**Date:** Geneva, 26 May 2016

**Underwear overlap, Update of Art.2 "Flame resistant clothing" of APPENDIX L CHAPTER III "Drivers' Equipment"**

Figure 1 – minimum overlapping at the neck area

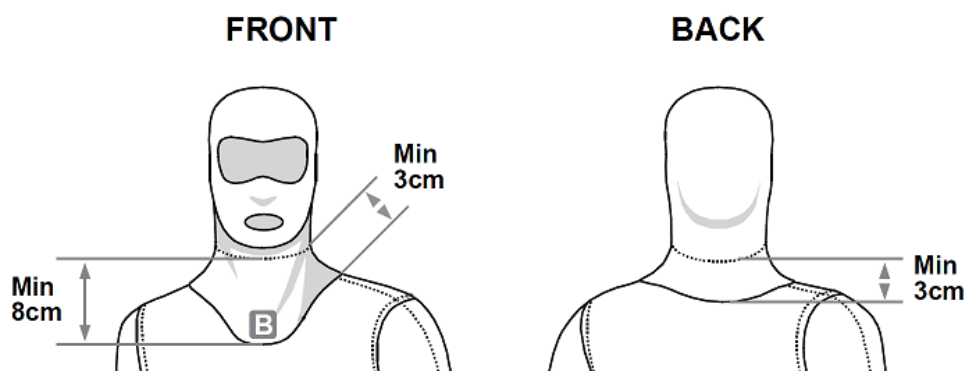
The driver's neck, wrists and ankles are vulnerable parts of the body. Therefore, these parts must always be covered by at least two articles of protective clothing. However, drivers have a tendency to use smaller underwear, and as a consequence the articles of clothing sometimes barely or do not overlap, especially around the neck area.

For this reason, the FIA has decided to define a minimum overlap required in the neck area (between the balaclava and the top underwear) of 3cm, except on the front central line where the overlap shall be at least of 8cm as shown in Figure 1.
